Report to the Independent Commissioners on the application for Resource Consent for a Qualifying Development under the Housing Accords and Special Housing Areas Act 2013 and Resource Management (National Environmental Standards for Assessing and Managing Contaminants in Soil to Protect Human Health) Regulations 2011

17 June 2019

Service Request No: 368659

<u>Site Address:</u>	232, 264, 270, 276, 277, 294, 296, 307 and 311 Shelly Bay Road, Maupuia
<u>Legal Description:</u>	Pt Sec 20 Watts Peninsula District, Sec 8-9 SO 339948, Sec 1 SO 37849, Sec 3 SO 339948, Sec 4-6 & 10 SO 339948, Section 2 SO 339948 and Pt Lot 3 DP3020
<u>Applicant:</u>	The Wellington Company Ltd
<u>Proposal:</u>	<p>Subdivision: 11 lot fee simple subdivision of land with road to vest</p> <p>Land Use (HASHAA): Redevelopment of the existing site including multi-unit residential, mixed use and non-residential buildings and activities, with associated earthworks</p> <p>Land Use (NES): Soil disturbance, change of use and subdivision of contaminated or potentially contaminated land</p>

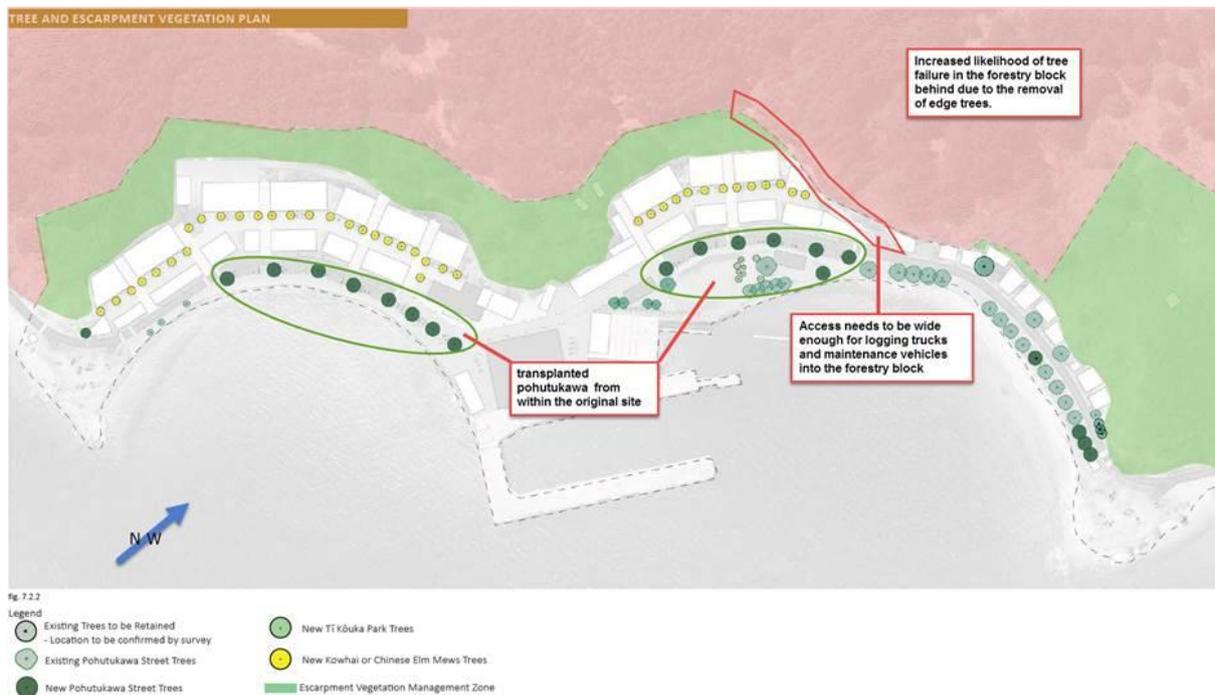
The main concern is the forestry block where the removal of the front row of pines from above the development site will lead to tree failure in the remaining block. It will be a similar situation to Karori Park, Spicer forest and Te Ahumairangi hill where the removal of the leading windward trees caused successive failures within the block and in the event of a

significant storm event a large percentage of the block will likely fail. This site is directly exposed to the north west winds and the proposed tree removal will create a problem in the future for the land owner and could potentially leave a wind thrown block on the flight path into wellington.

There is also the opportunity to enhance the site in the long term through transplanting some of the existing trees and considering minor changes to tree species lists.
